# ADDENDUM

**Project:** WSC – Carlson Natatorium and Recreation Center Chilled Water project

**Project No.:** 12072-212

**Addendum No.:** 1

##### **C. Carlson Natatorium Balcony Plan**

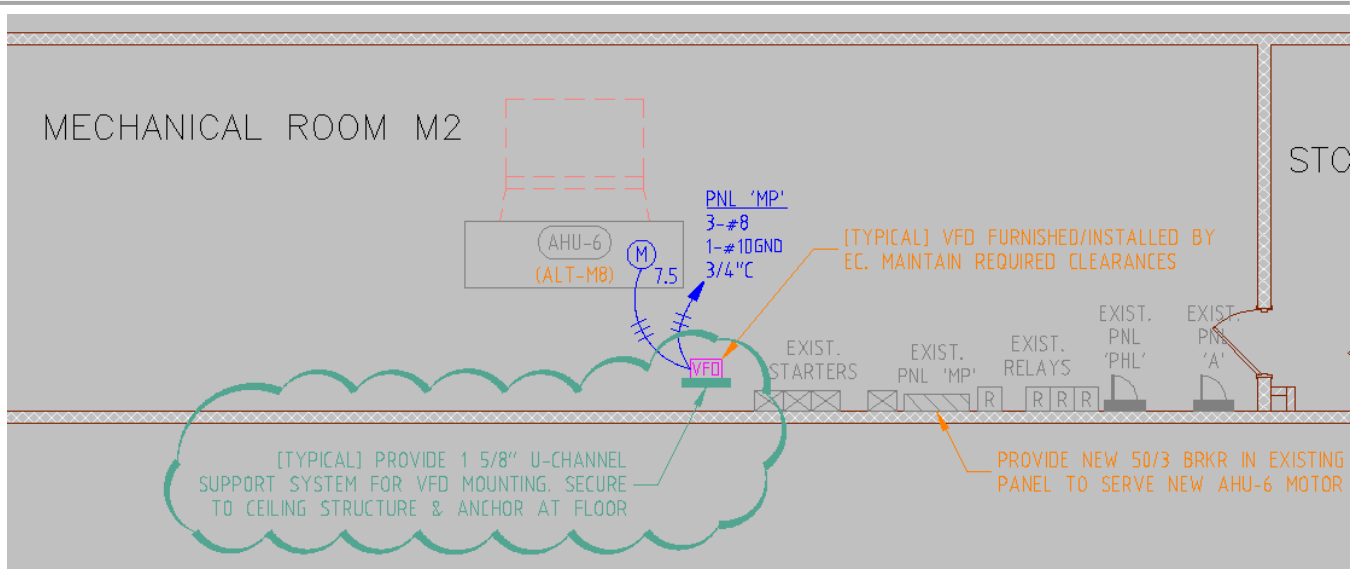
1) Due to space restrictions, VFD for AHU-6 shall be mounted on u-channel support frame system away from wall as shown below. Provide u-channel system with all required accessories and securely attach to floor and wall.

M 3 **CARLSON NATATORIUM BALCONY PLAN VIEW**  
M2.0 SCALE: 1/8"=1'-0"

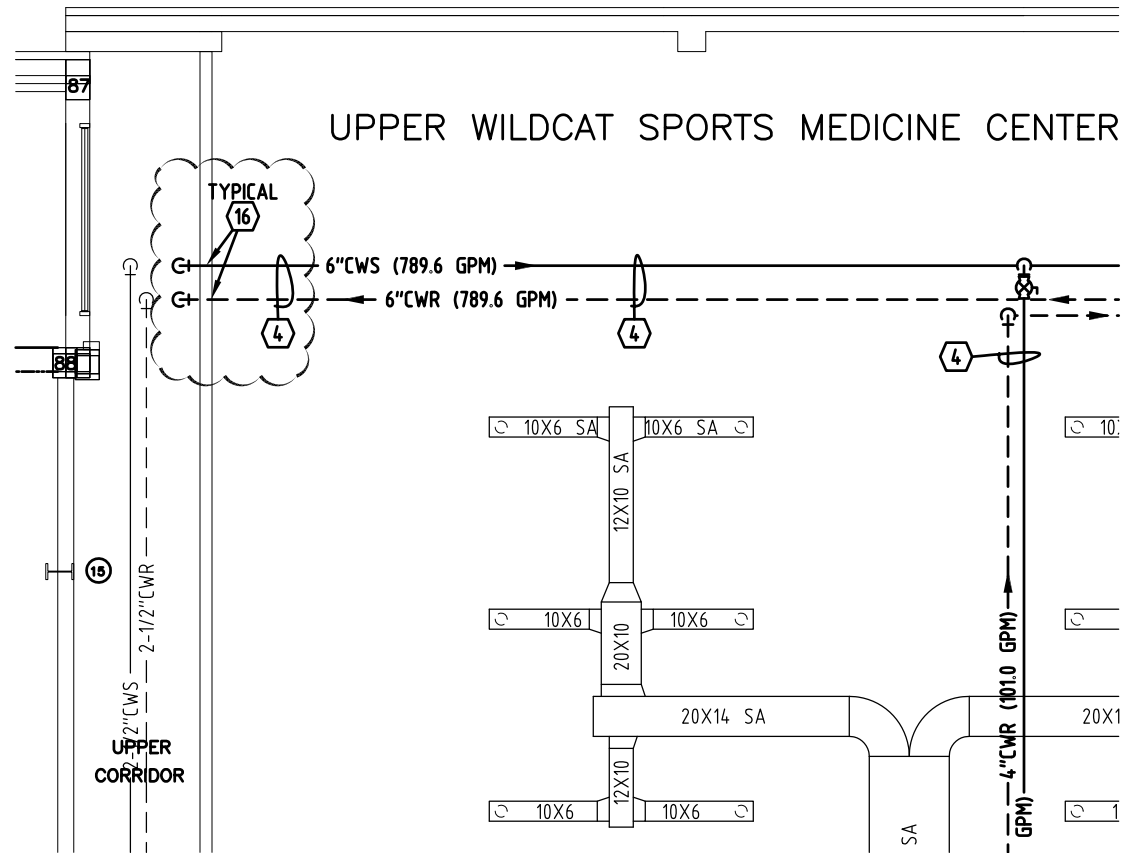
1) Add note 16. (see attached drawing page 1 of 1 on sheet M2.0). Typical per wall/ceiling penetration.

- 15. INSTALL NEW CONTROL VALVE IN CHILLED WATER PIPING (PROVIDED BY CONTROLS CONTRACTOR).
- 16. WALLS AND CEILINGS TO BE PATCHED AND REPAIRED AFTER NEW PIPING IS ROUTED THROUGH SAID WALLS AND CEILINGS. TYPICAL ALL LOCATIONS WHERE NEW PIPING PENETRATES EXISTING WALLS.
